Report to the Future Melbourne (Planning) Committee

**Ministerial Referral: TPM-2014-43
57-63 Exhibition Street, Melbourne**

21 March 2017

**PLANNING REPORT
MINISTERIAL REFERRAL**

Figure 3: Excerpt from 'Shadow Study 22 June 11AM' prepared by Bates Smart

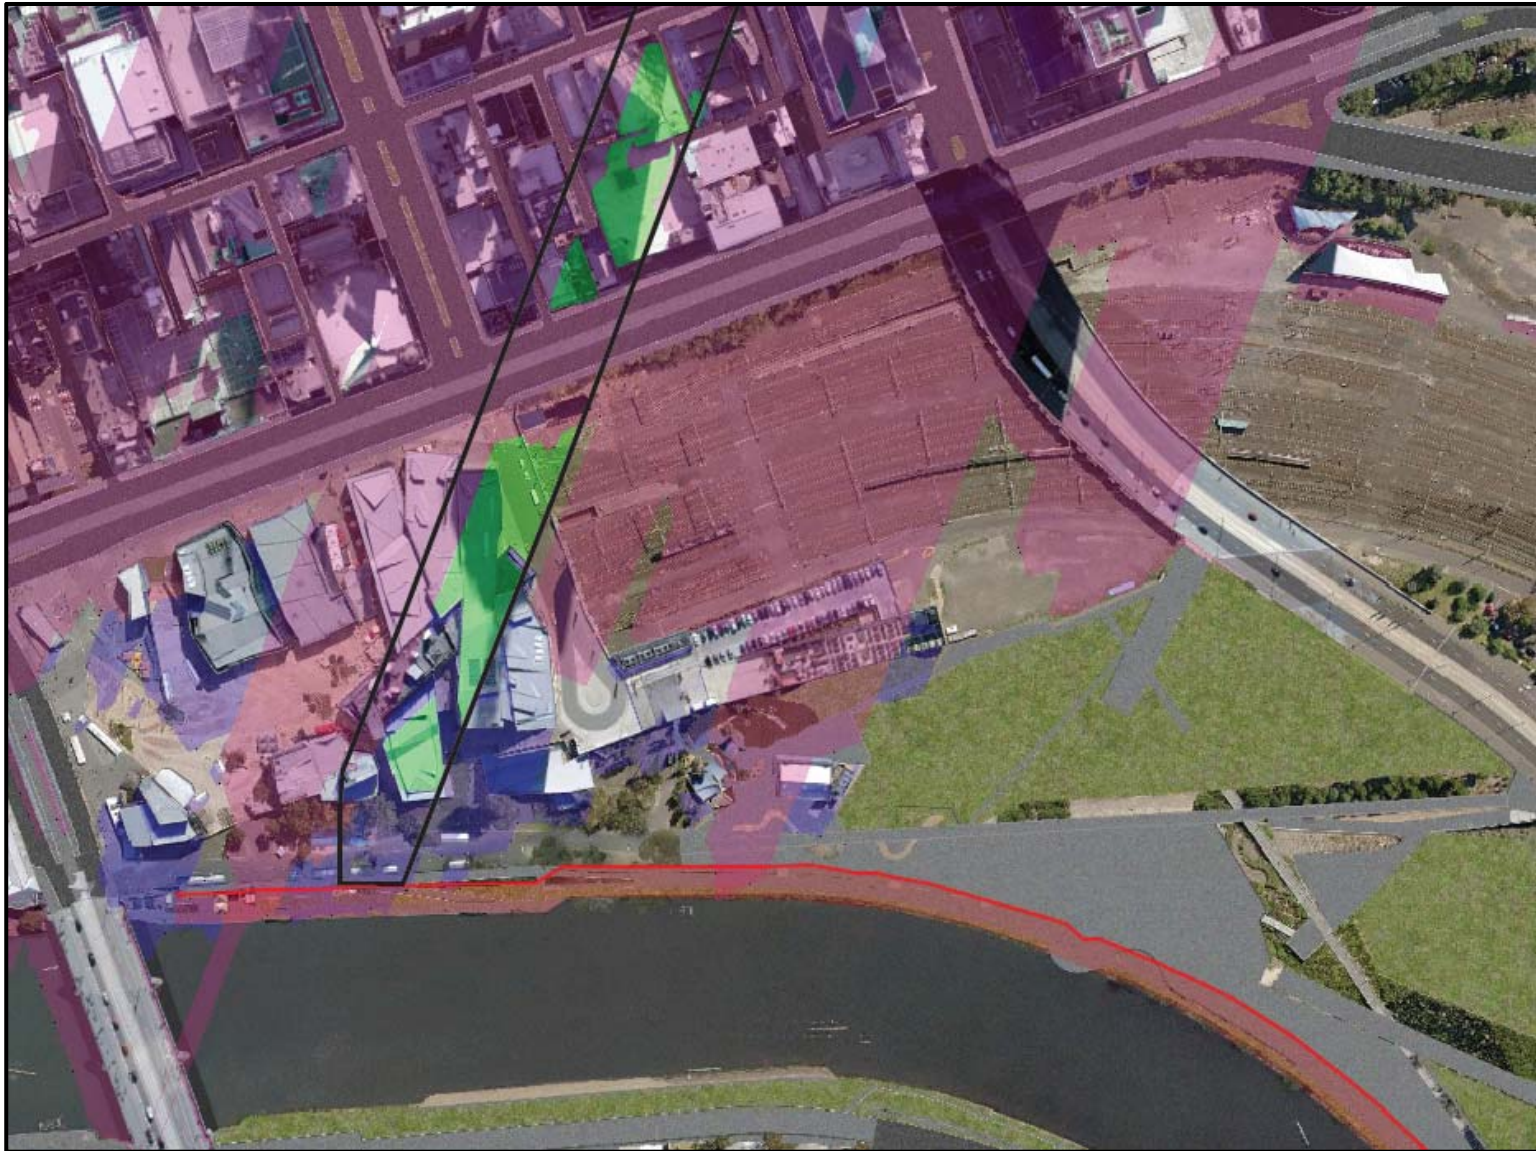
- The height of the proposed tower, RL 230.00 (corresponding to a height of 203.57 metres as measured from a spot level of RL 26.43 at the centre of the Exhibition Street frontage), appears to be a product of various local planning policy settings that have sought to limit the height of new development to prevent further shadowing of the north bank of the Yarra River (inclusive of a 15 metre wide strip of land extending north of the river edge) between 11.00am and 2.00pm on 22 June.

Figure 3 below includes an excerpt from shadow studies prepared by Bates Smart for 22 June at 11.00am, delineating the extent of the shadow cast by the tower (bold black line), in addition to the 'north bank' of the Yarra River (bold red line).

- The overshadowing associated with the proposed development will contribute to a significant loss of sunlight over Birrarung Marr, impacting on the Lower, Middle and Upper Terrace, as detailed in Figure # above.

7. To resolve the above issues, a number of conditions have been recommended for inclusion on any permit being granted, requiring; a reduction in the height of the tower to 183 metres to limit overshadowing impacts upon Birrarung Marr, fenestration to the southern boundary wall above a height of 80 metres, supporting material to demonstrate the feasibility of the angular glazed panel façade strategy, and a detailed plan of the ground floor plane responding to a number of specified criteria.

Figure 5: Excerpt from '2.11 Planning Context Tower Separation' prepared by Bates Smart

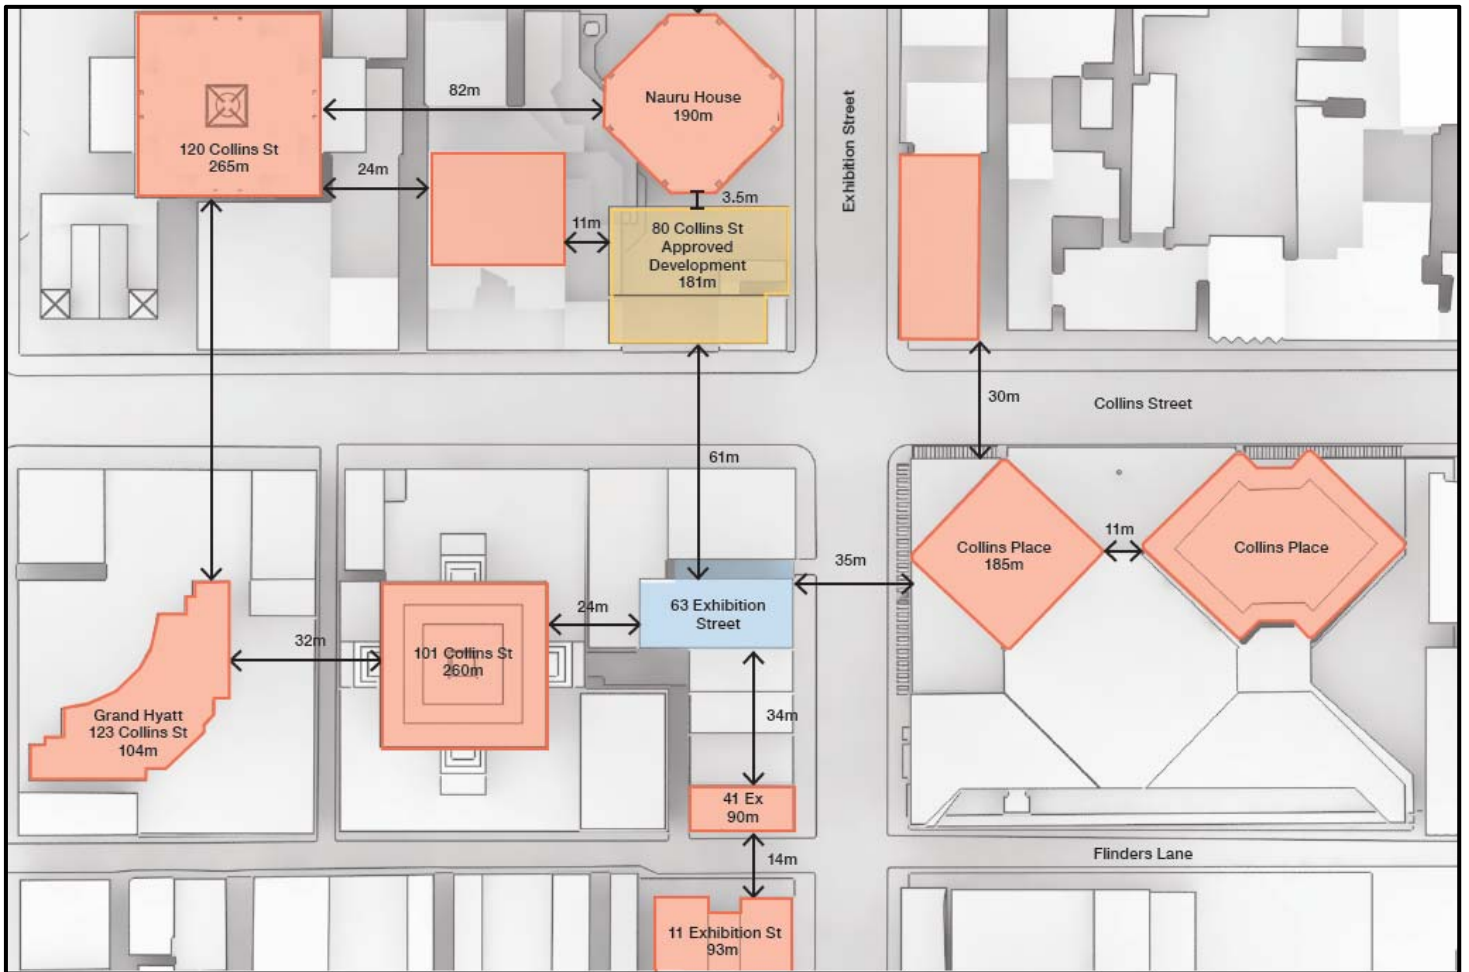
- The proposed tower will achieve minimum separation of 24 metres from the nearest tower (101 Collins Street).

Figure 5 overleaf includes an excerpt from a diagram prepared by Bates Smart to demonstrate tower separation between the proposed development and surrounding city blocks, generally demonstrating that the proposed tower will achieve adequate separation from any neighbouring towers exceeding a height of 40 metres.

- The primary issue presented by the proposed building envelope, which attracted concerns from Council's Urban Design Advisor in his advice referenced in Section 7.1.1 of this report, is the zero setback to the south property boundary shared with 53-55 Exhibition Street.

Figure 7: Excerpt from 'Immediate Context – Future Development' prepared by Bates Smart

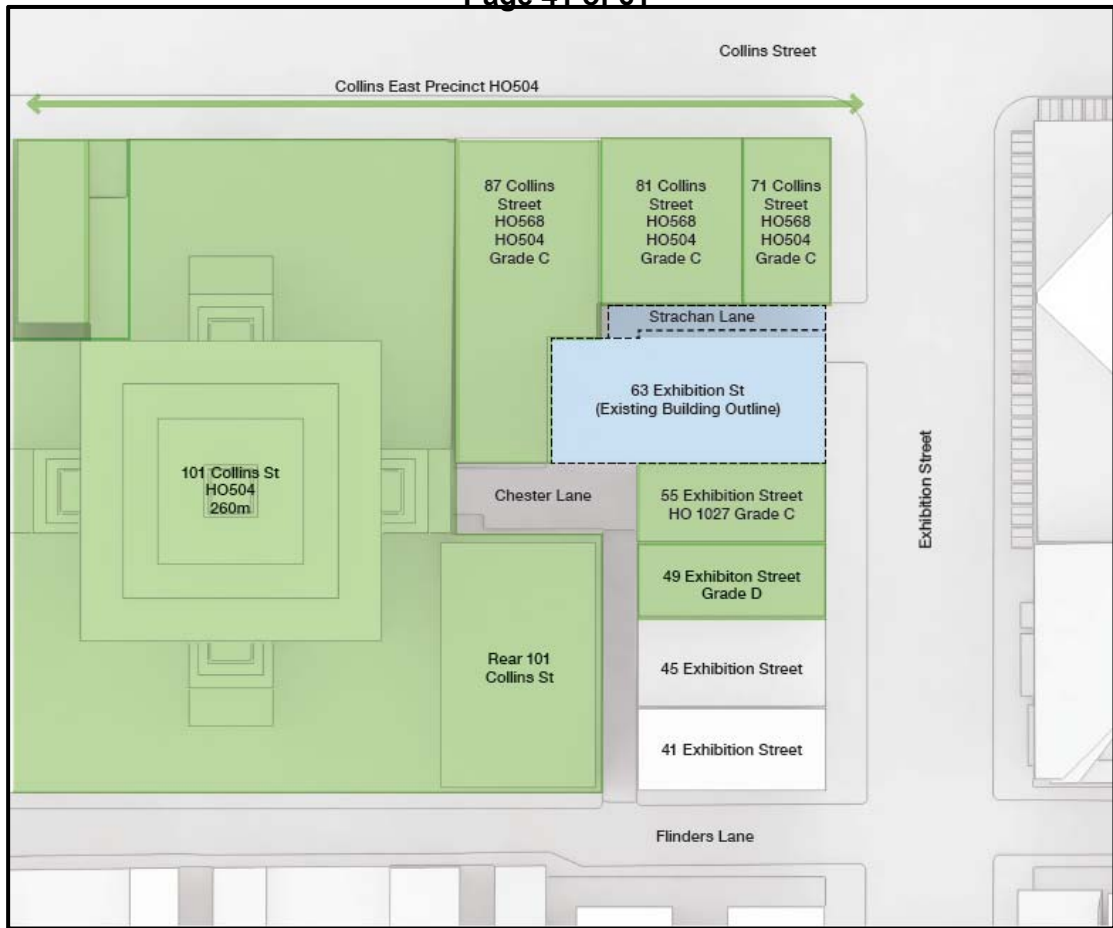
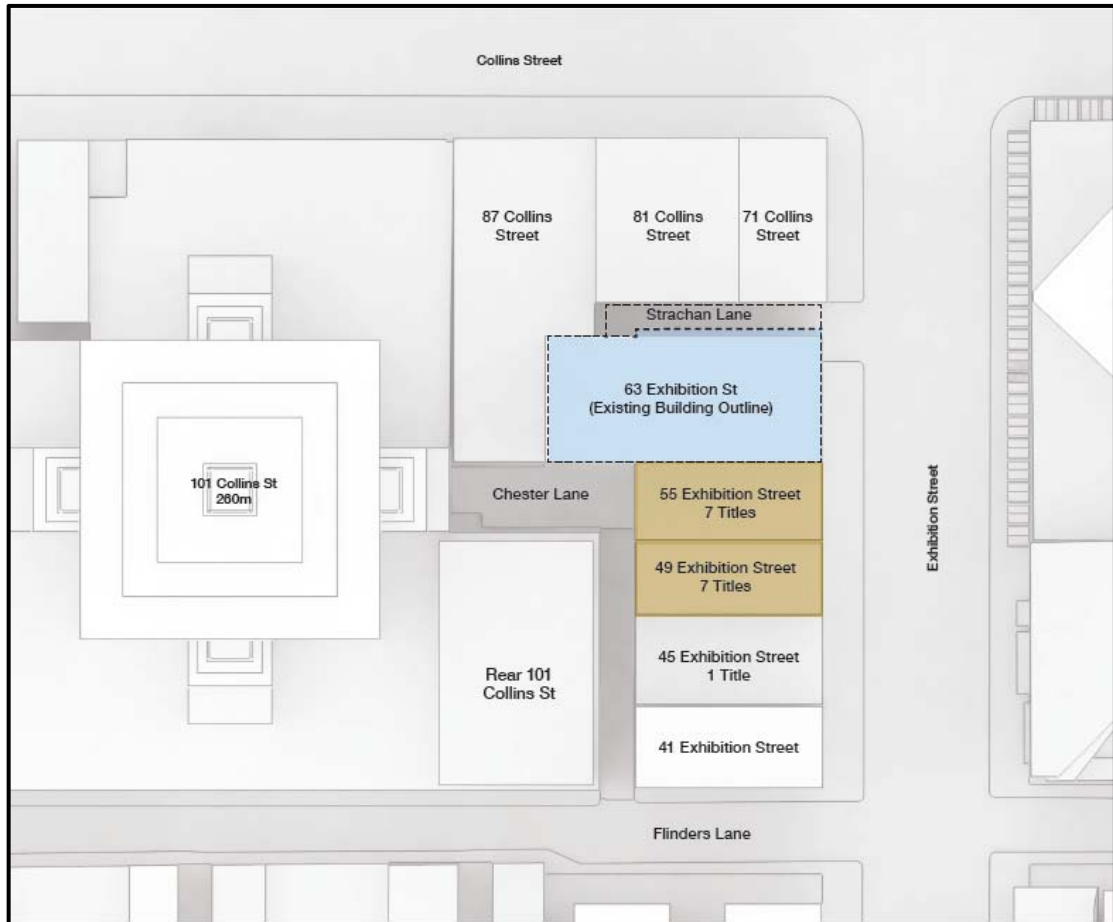
The planning report prepared by Urbis Pty. Ltd advances the following arguments in support of the proposed zero setback, having regard to the equitable development opportunities of the adjoining property at 53-55 Exhibition Street, which have been accepted by Council:

- 53-55 Exhibition Street is occupied by a graded historic building protected under a site specific Heritage Overlays, limiting the scale of potential future development (see Figure 7 overleaf for a map showing heritage protected properties surrounding the subject property).

- The title to 53-55 Exhibition Street and its neighbouring property to the south, 49 Exhibition Street, have been strata-subdivided and are subsequently in fragmented ownership (currently in use for dwellings) limiting the likelihood of these lots being consolidated to enable development (see Figure 8 on page 23 above for a map showing fragmented titles surrounding the subject property).
- Per analysis by Bates Smart, in the unlikely event that the adjoining property to the south at 53-55 Exhibition Street and its neighbour at 49 Exhibition Street were consolidated, Schedule 10 to the Design and Development Overlay would render development of a tower form with a height greater than 80 metres on the consolidated property unviable.

A reasonable requirement, having regard to the likely development envelope for the adjoining property at 53-55 Exhibition Street, and the need to provide a degree of activation to the southerly façade of the proposed development, would therefore be to condition the provision of windows to bathrooms on floors above RL 107.00, to the south façade abutting the shared property boundary with 53-55 Exhibition Street, Melbourne.

Figure 9: excerpt from plan titled '1.4 Strachan Lane Podium Projection, prepared by Bates Smart

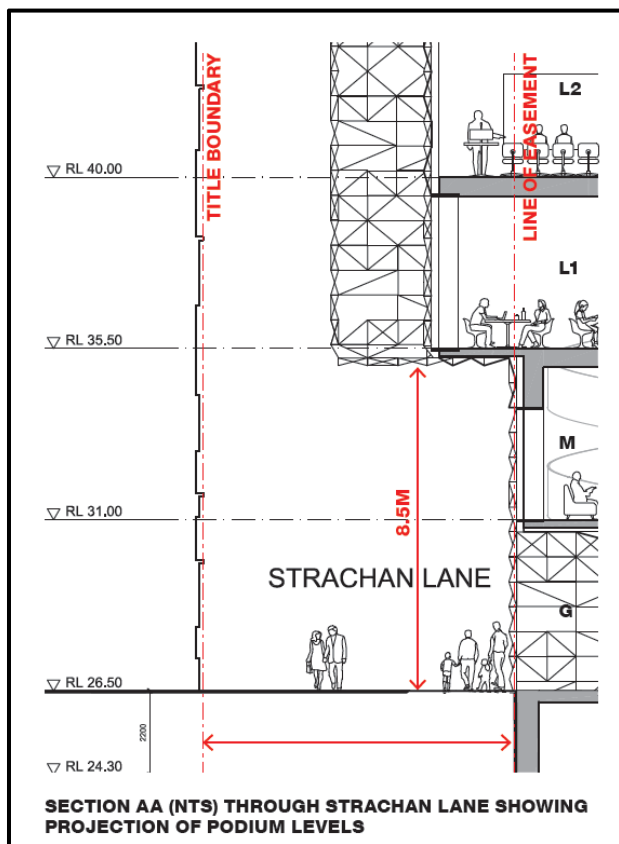
- The north-west corner of the podium (measuring 2.334m x 7.189m) and tower (measuring 1.034m x 7.189m) will project over easement 'E-1' on Title Plan 819012Q, representing the current Strachan Lane alignment.
- Detailed plans provided by the applicant showing the extent of this encroachment over Strachan Lane identify that the minimum clearance from the laneway surface to the underside of the cantilevered podium is 8.5 metres (see Figure 9 below).

It is noted that the encroachment of the podium over Strachan Lane (easement E-1 on Title Plan 819012Q) has previously been considered by Council's Engineering Services Branch at a meeting held on 24 March 2016, where no concerns were identified subject to adequate clearance being provided above the laneway surface in accordance with Council's Road Encroachment Operational Guidelines.

- Subject to conditions recommended by Council's Land Survey team being included on any permit being granted, prompting the permit holder to obtain approval to build over easement E-1 on Title Plan 819012Q from Melbourne City Council it is considered the development will achieve compliance with Clause 22.01-6.

Prior to the occupation of the development the land shown as E-1 on TP819012Q which is known as Strachan Lane (being CL452) must be vested in Council on a Plan of Subdivision to the satisfaction of the Responsible Authority. The portion at the rear may be limited in height to exclude any structure which must be a minimum of 5 metres above the existing surface of Strachan Lane.

Figure 10: Excerpt from 'Accessibility Marked Plan' (Ground Floor) dated 17 May 2016 prepared by Du Chateau Chun Pty. Ltd.

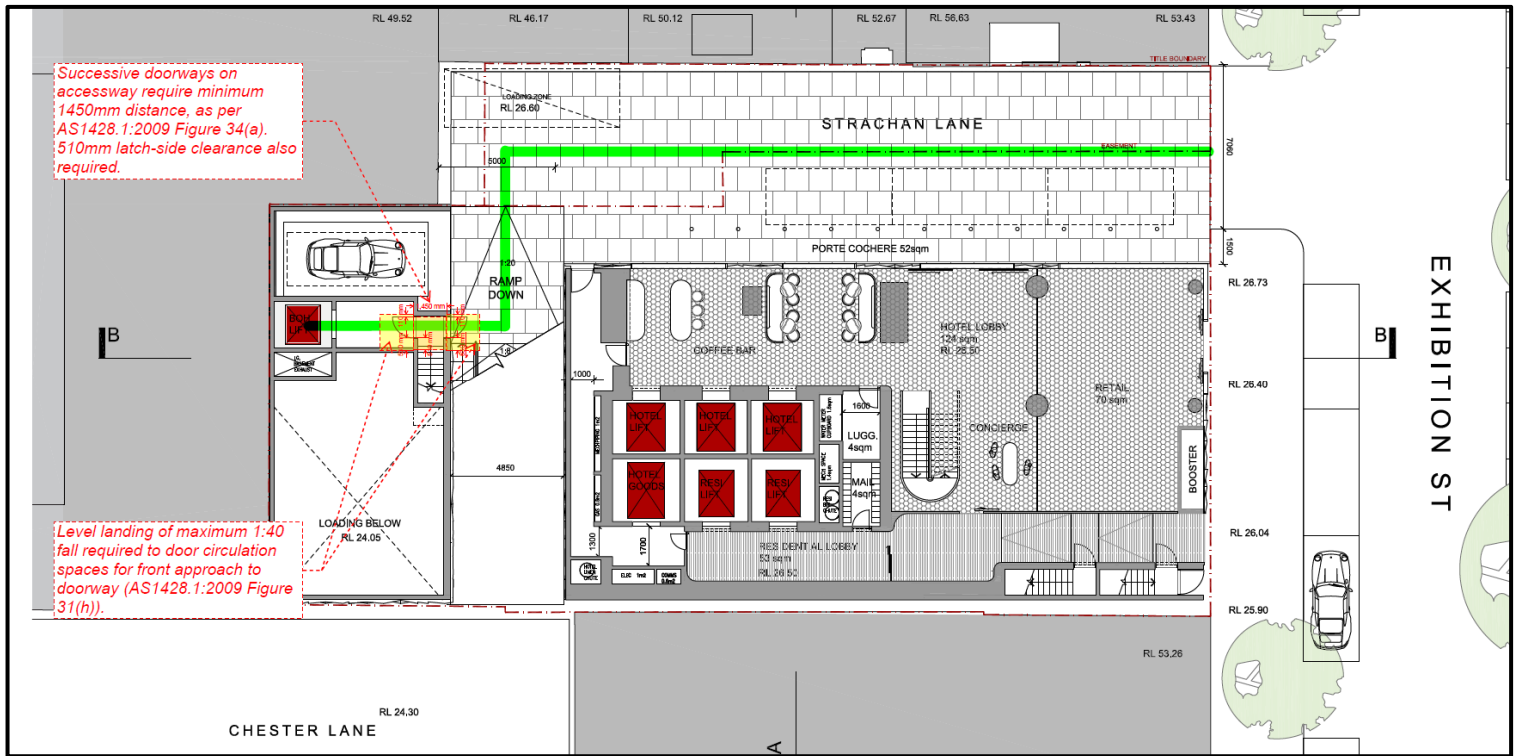
- Employment of an alternative response to provide DDA compliant access via the through-block link that does not rely on a concierge operated lift with egress through a loading bay.

The advice and solution offered by Du Chateau Chun Pty Ltd will result in a highly segregated and unequal outcome for persons with disabilities, and is not considered to represent an appropriate outcome for a public thoroughfare (see Figure 10 and Figure 11 overleaf for excerpts from the wayfinding plan prepared by Du Chateau Chun Pty Ltd.).

- v. Employ an alternative response to provide DDA compliant access via the through-block link that does not rely on a concierge operated lift with egress through a loading bay.

Figure 12: Excerpt from report prepared by MEL Consultants Pty. Ltd. dated June 2016 detailing wind conditions at ground level for proposed development.

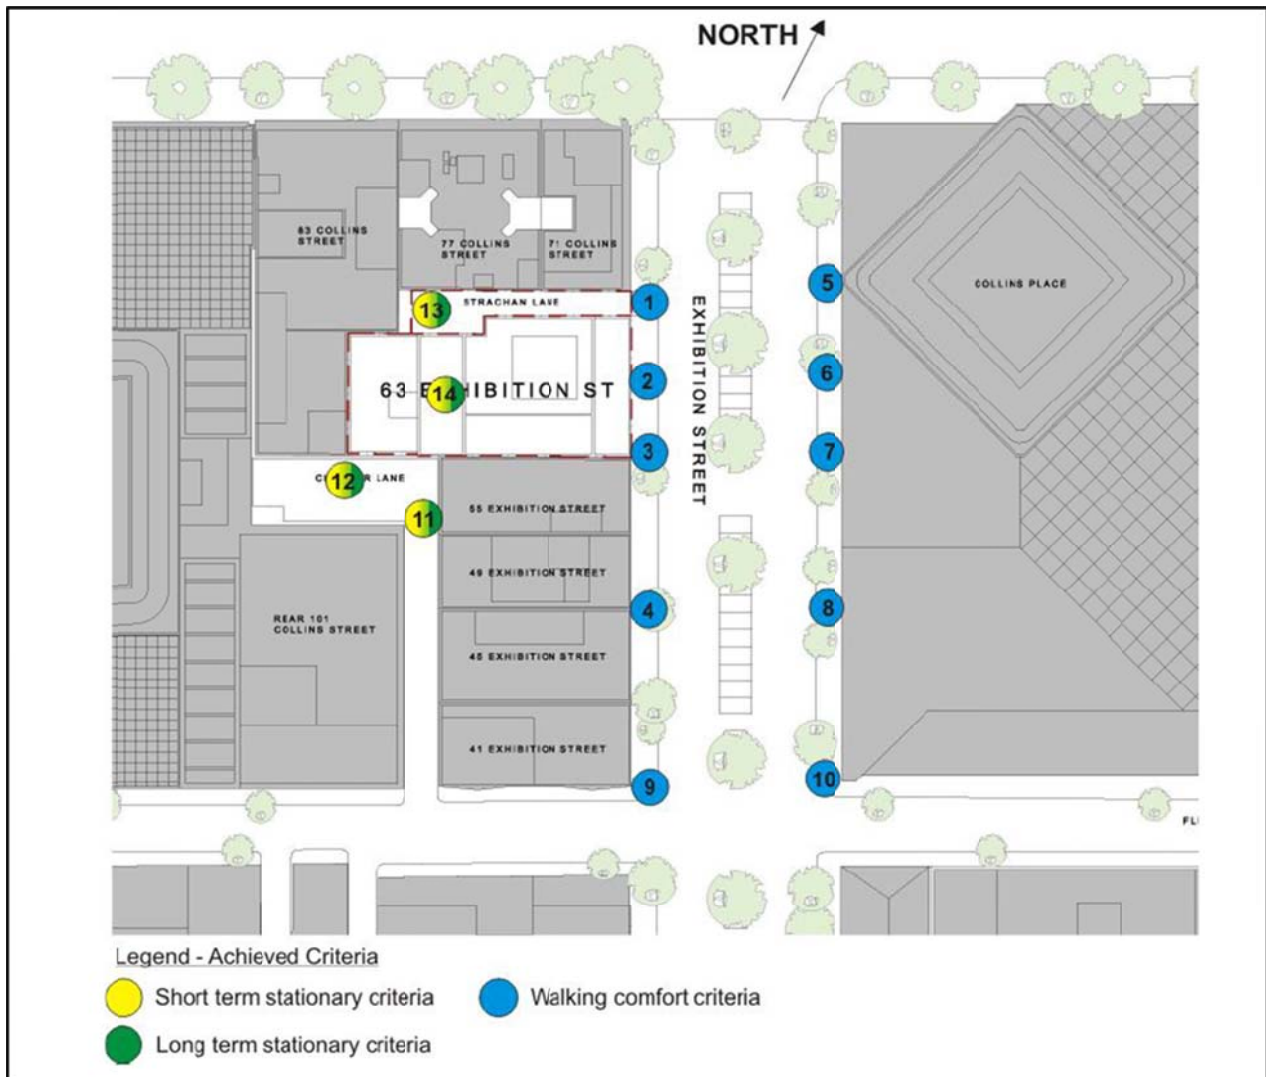
The report prepared by MEL Consultants Pty. Ltd. dated June 2016, which documents findings from a wind tunnel model of the proposed development, identifies that the proposed development will meet specified short and long term stationary comfort criteria, and walking comfort criteria in accordance with the excerpt from this report provided below in Figure 12.

As detailed in section 8.6.1 of this report above, subject to a condition being included on any permit being granted requiring provision of a canopy over the residential apartment entry to provide protection for residents of the building, the development will not contribute detrimentally to wind speeds at ground level, or compromise pedestrian comfort and amenity.
